## 00/300 AREA UNIT MANAGER MEETING

100/300 AREA UNIT MANAGERS MEETING  
APPROVAL OF MEETING MINUTES  
January 8, 2009

**Agreement:** Attachment 10 (narrative), Attachment 11 (excel table with proposed sampling changes), and Attachment 12 (maps showing location of sampling points in Attachment 11) are proposed changes to the *Remedial Investigation Work Plan for Hanford Site Releases to the Columbia River*, DOE/RL-2008-11, Rev. 0. RL, EPA, and Ecology approve the proposed changes as outlined in these three attachments.

Figure 2-17

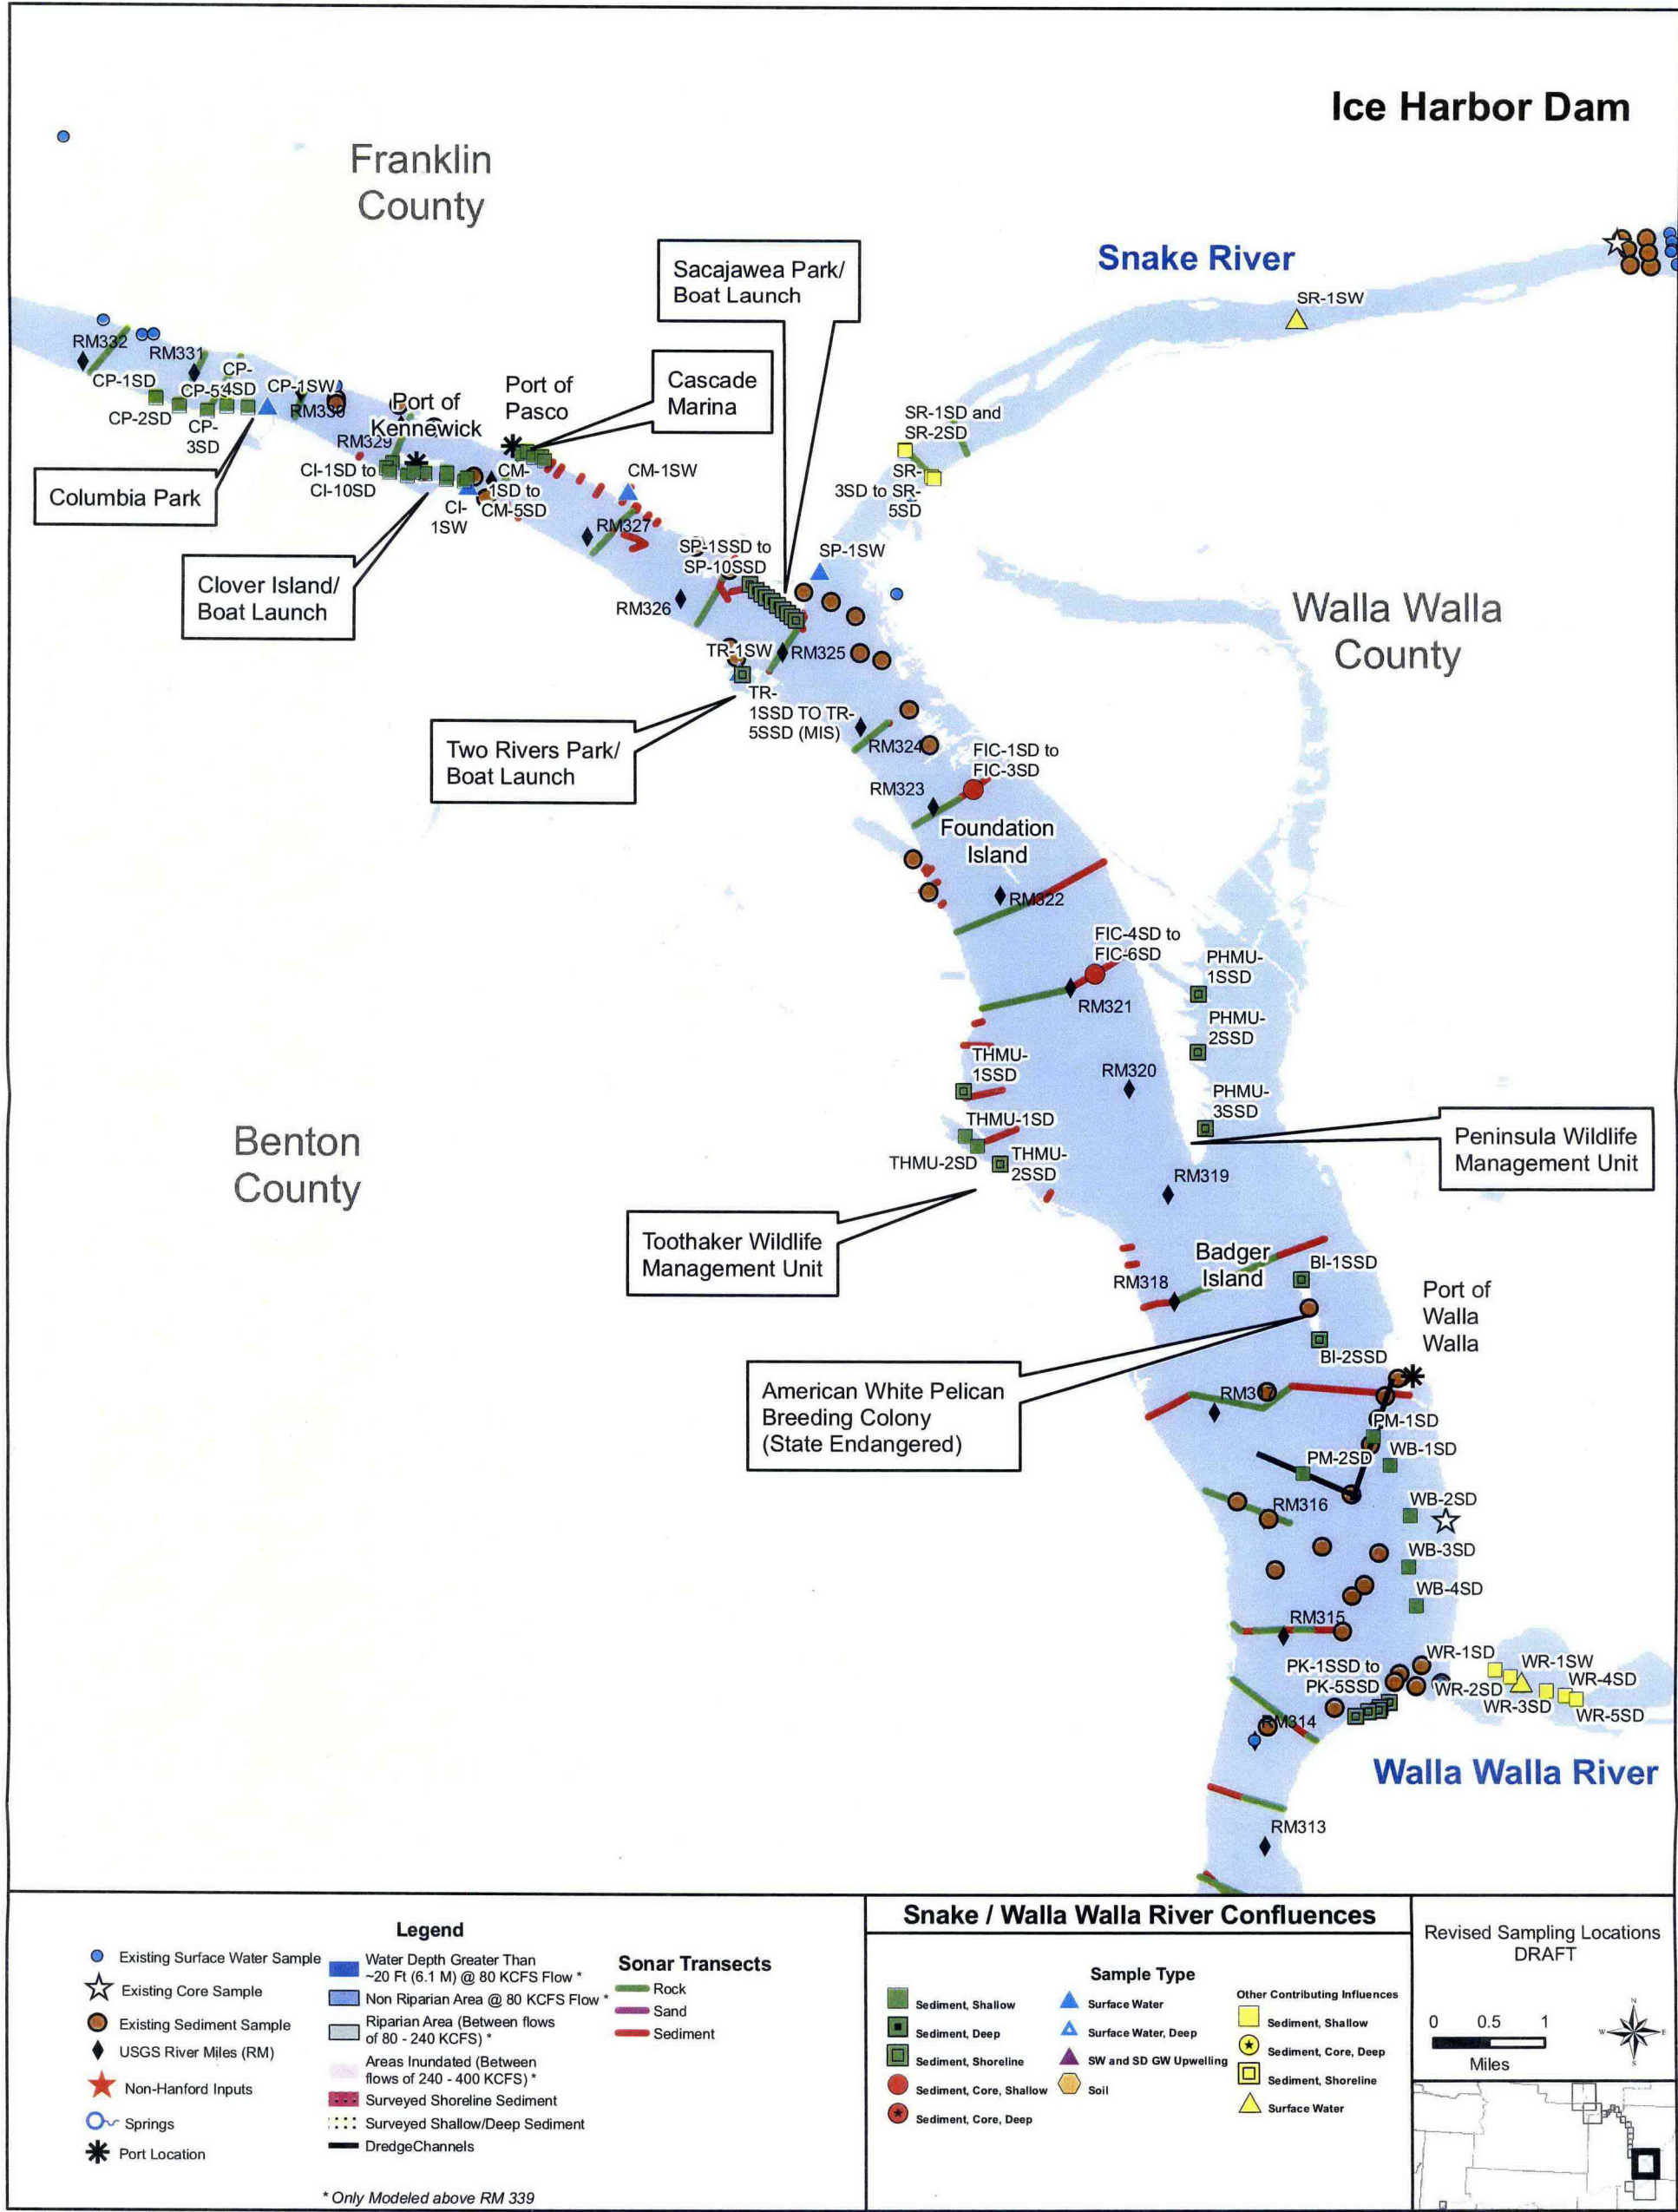
Figure 2-17	Recreational	Sediment, Shoreline	Grab	Clover Island	CI-1SSD to CI-10SSD	Eliminated all Shoreline.	None	All	10	-	-	Random/Stratified	0 - 0.3 ft	Ten sediment samples will be randomly collected from the shoreline area of Clover Island from a 10 cell grid.
Figure 2-17	Recreational	Sediment, Shallow	Ponar	Clover Island	CI-1SD to CI-10SD	Add 10 new shallow sediment samples. No shoreline sediment observed.	All	-	-	Add CI-1SD to 10SD	10	Random/Stratified	0 - 0.3 ft	Ten sediment samples will be randomly collected: 3 from upriver of causeway and 7 from within boat basin.
Figure 2-17	Recreational	Sediment, Shoreline	Grab	Two Rivers Park (5 replicate)	TR-1SSD to TR-5SSD	Limited; grid to be established in field	All	-	-	-	-	MIS	0 - 0.3 ft	One MIS sample will be collected at 5 replicate from the shoreline area of Two Rivers Park.
Figure 2-17	Recreational	Sediment, Shoreline	Grab	Cascade Marina	CM-1SSD to CM-10SSD	Eliminated all Shoreline.	-	All	10	-	-	Random/Stratified	0 - 0.3 ft	Ten sediment samples will be randomly collected from the shoreline area of Cascade Marina from a 10 cell grid.
